Detailed Site Plan Alternative Compliance Washington Square

DET-2022-009
ACL-2023-006

STAFF REPORT

SUBJECT: Detailed Site Plan DET-2022-009
Alternative Compliance ACL-2023-006
Type 2 Tree Conservation Plan TCP2-040-2023
Washington Square

Figure 7: South phase with Benjamin Drive with no Sidewalk.

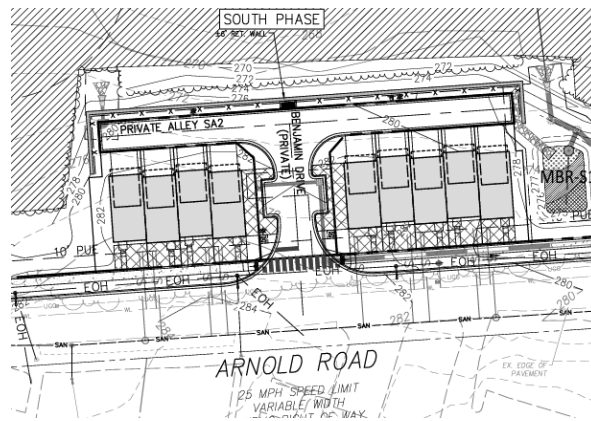
Proposed development conforms with this requirement, with one exception [South Phase: Benjamin Drive (private street) connecting the private alley to Arnold Road is proposed without sidewalks]. This is only one lot depth street which leads to the alley. There is no need to lead pedestrians to the back alley where only vehicular traffic occurs. This condition is reasonable, and staff support the waiver per section 27-6207(a)(2)(c).

Figure 8: Perimeters 3 and 5 location for Alternative Compliance Request

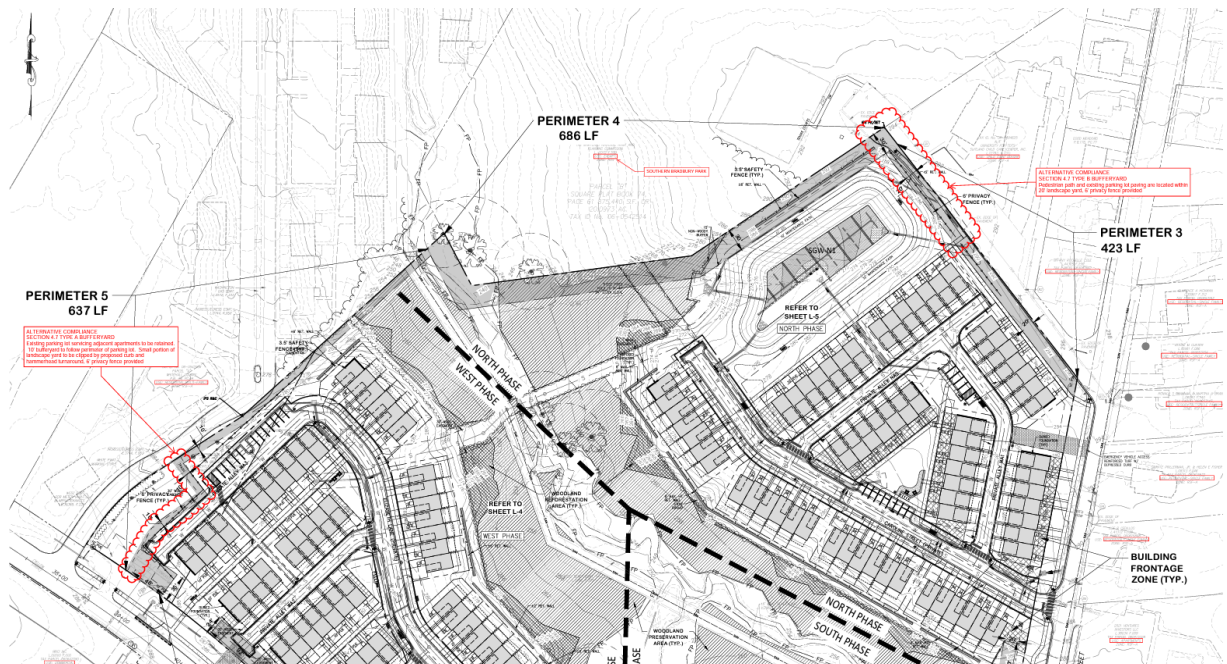
- D. **2018 Prince George's County Landscape Manual:** Alternative compliance (ACL-2023-006) is requested for Section 4.7, Buffering Incompatible Uses, of the Landscape Manual along Perimeters 3 and 5, shown on the figure below.

The applicant has requested alternative compliance to preserve existing pavement at the northeastern corner of the property to provide a pedestrian path. This path leads to the adjacent improved Maryland-National Capital Park and Planning Commission park and is located within the required 20-foot-wide landscape yard. The applicant will not provide any landscaped bufferyard where this path is located.

An existing parking lot serving multifamily uses to the northwest is located in the northwestern corner of the subject property. In order to retain this parking lot, the applicant will provide the required 10-foot-wide landscape yard between the existing parking lot and the townhouse development rather than along the property line.

1. Prior to certification of DET-2022-009, the following revisions shall be made, or information provided:
 - a. Provide additional shade or evergreen trees around the end of the private alley (NA 2), between Lots 107 and 108.
 - b. Provide additional evergreen trees around the east corner of the existing parking lot, near the rear of Lots 65 and 66.
